<u>Dart18 Class Rule Changes Agreed by the IDRC September 2017</u> <u>For general circulation.</u>

Jib strop to jib clew amendment.

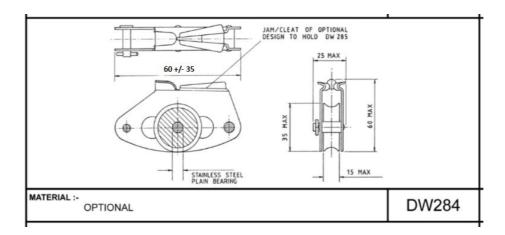
The snap hook DS404 can now be replaced with a ball and short length of line. The length of the jib strop is unchanged from its original overall length.

Overall length of trapeze adjuster amendment.

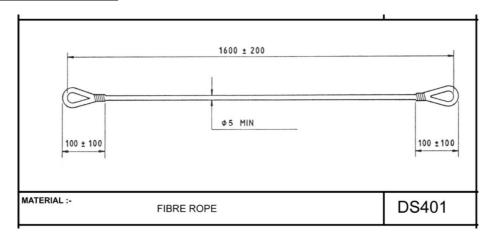
The overall length of DW284 has been adjusted such that the maximum length is 95mm.

Jib strop diameter amendment.

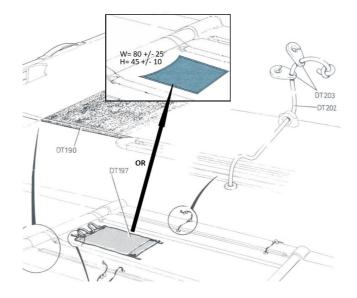
Minimum diameter of the jib strop is reduced to 5mm.
